SUBJECT: RESPONSES TO STAFF REQUESTS REGARDING THE AP600 INSPECTIONS,
TESTS, ANALYSES, AND ACCEPTANCE CRITERIA (ITAAC) - IRWST &
RECIRC SCREENS

Enclosed are three copies of Westinghouse's revised response to RAI 480.1079 related to comments received from the staff related to the IRWST and recirculation screens during the AP600 ITAAC Task Group meeting on December 4, 1997.

RAI 480.1079 (OITS #5740)

Figure 6.3-8

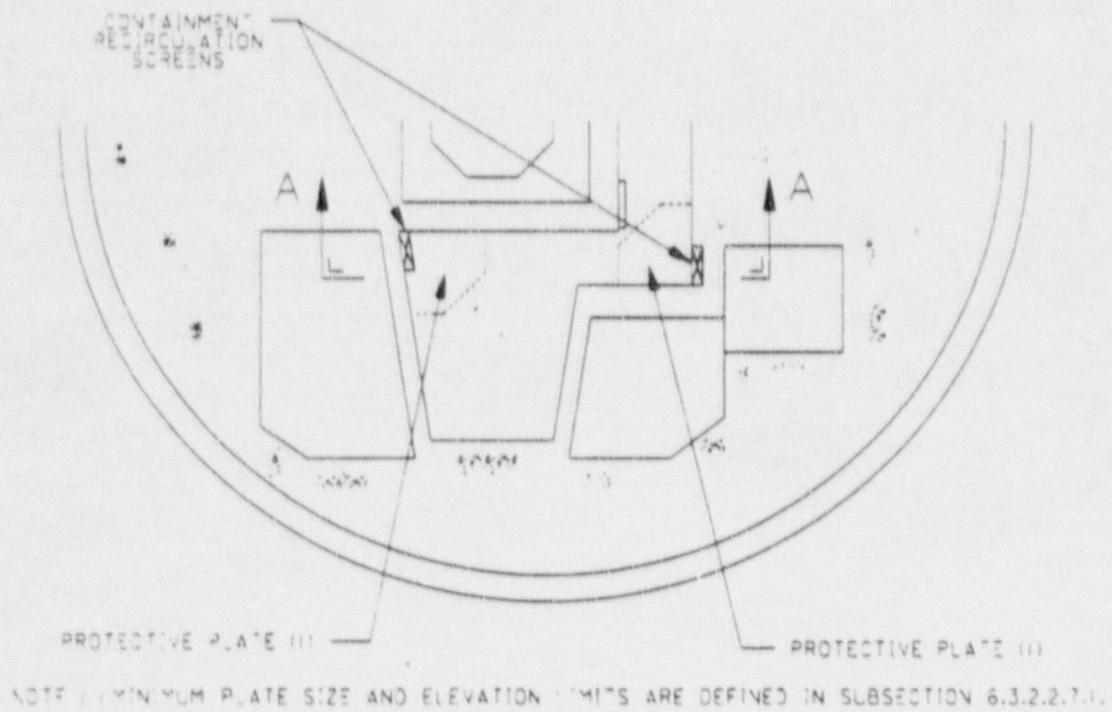
Revise figures 6.3-8 and 6.3-9 (attached) to show plates over screens.

- Screens have solid top cover containment recirculation screens have protective plates that are located no more than 10 feet above the top of the screens and extend at least 10 feet in front and to the side of the screens.

The containment recirculation screens are oriented vertically along walls above the loop compartment floor (elevation 83 feet). Figure 6.3-8 shows a plan view and Figure 6.3-9 shows a section view of these screens. Two separate screens are provided as shown in Figure 6.3-3. The loop compartment floor elevation is significantly above (11.5 feet) the lowest level in the containment, the reactor vessel cavity. The bottom of the recirculation screen is two foot above the floor, providing a curb function.
